PERMIT

SEWAGE DISPOSAL SYSTEM

SUBDIVISION Walnut Springs LOT 17 ROAD 1247 Emmaus Road

Approved Septic System Plan
Howard County Health Department

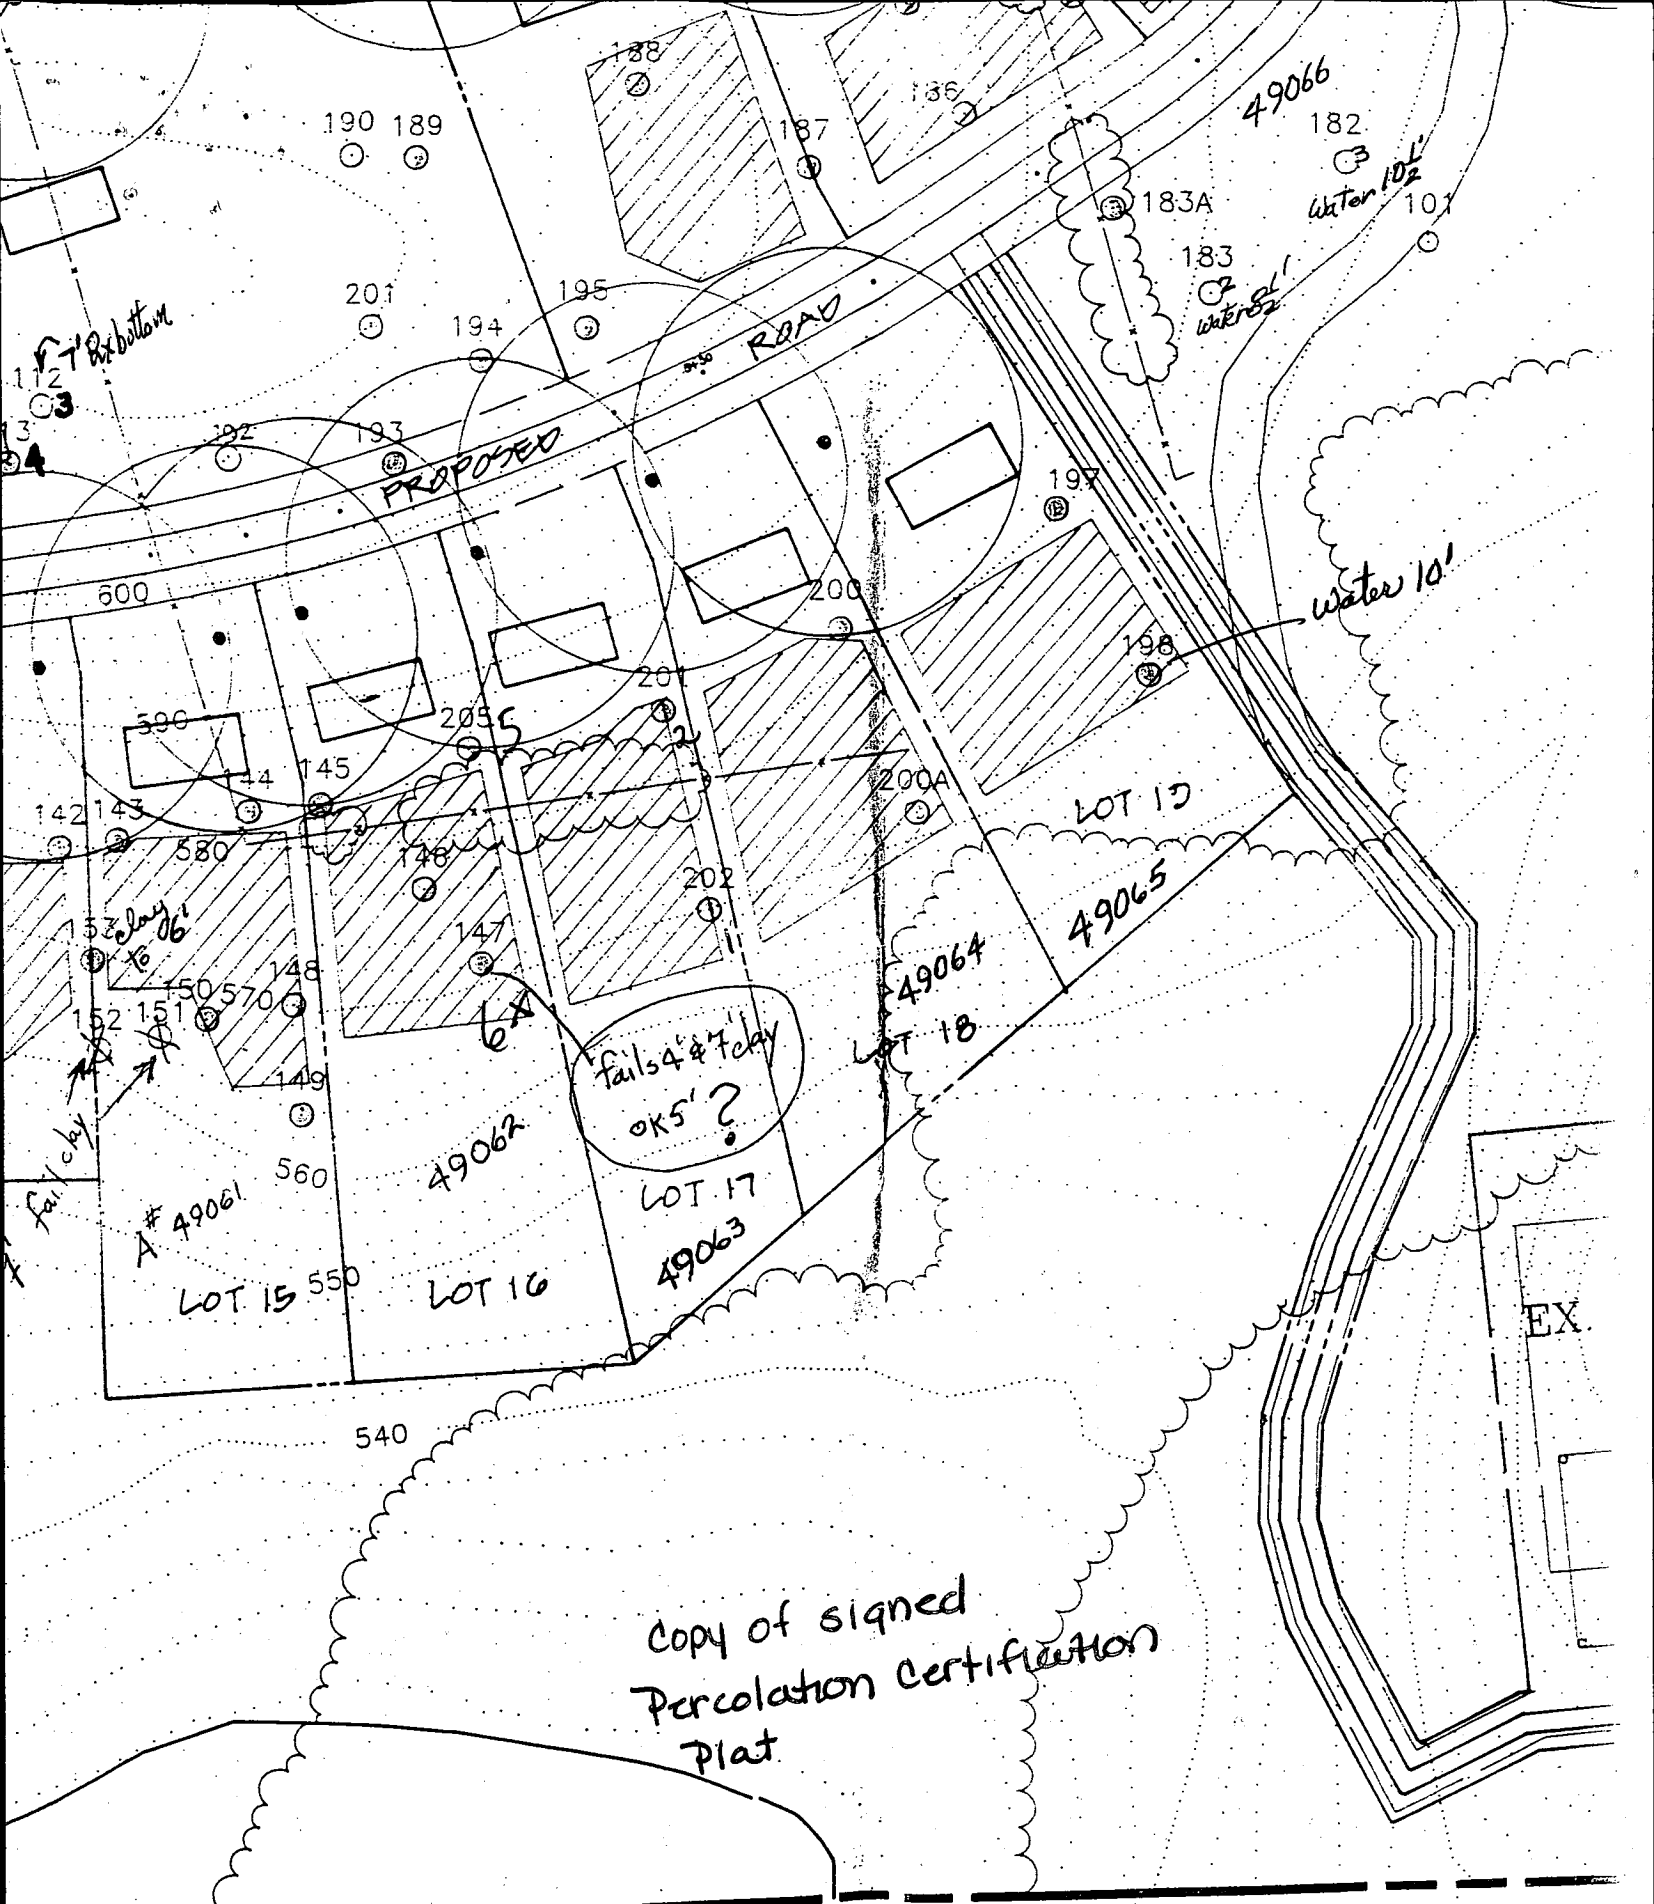
Manhole clo
required on septic
tank.
Length of trench
to be determined
at time of septic
permit issuance

Copy of signed
Percolation Certification
Plat.

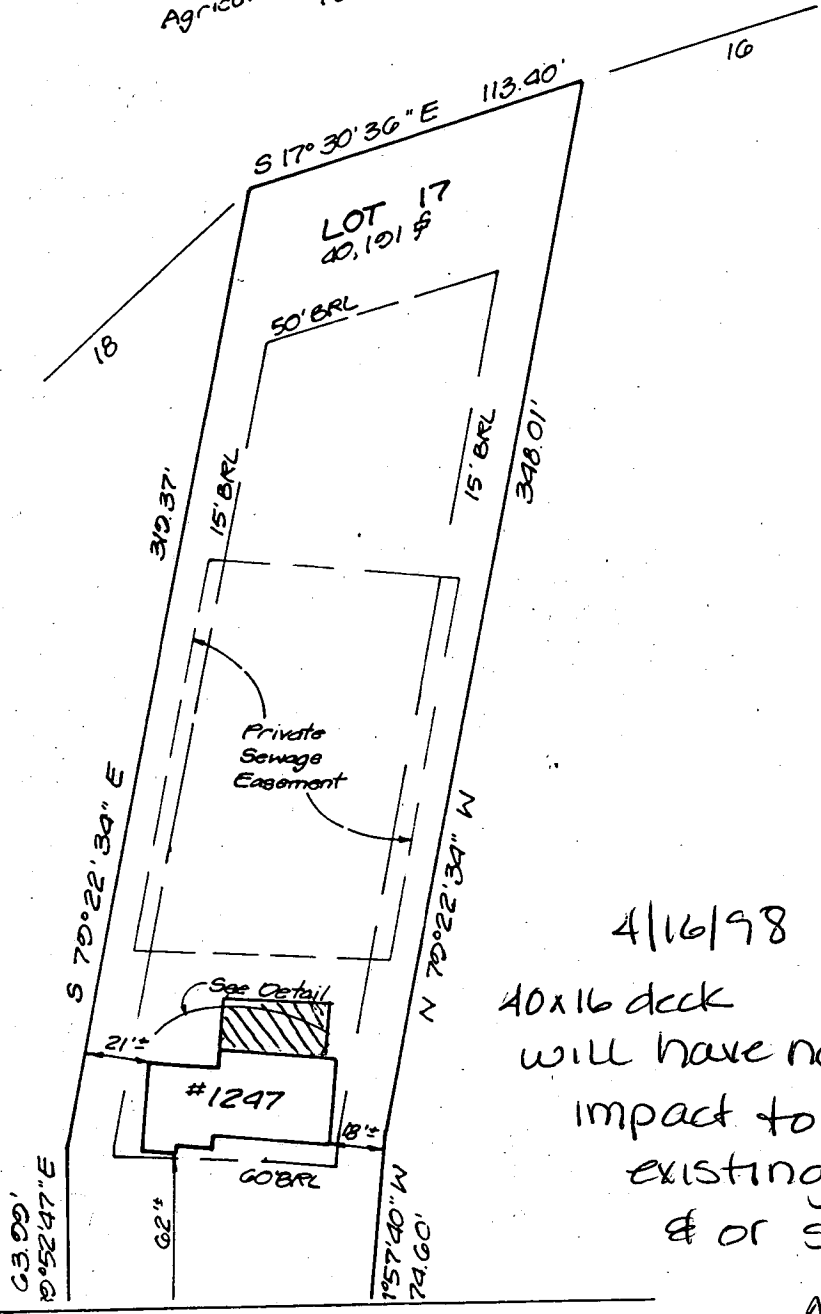
4/16/98
40x16 deck
will have no
impact to the
existing well
& or septic
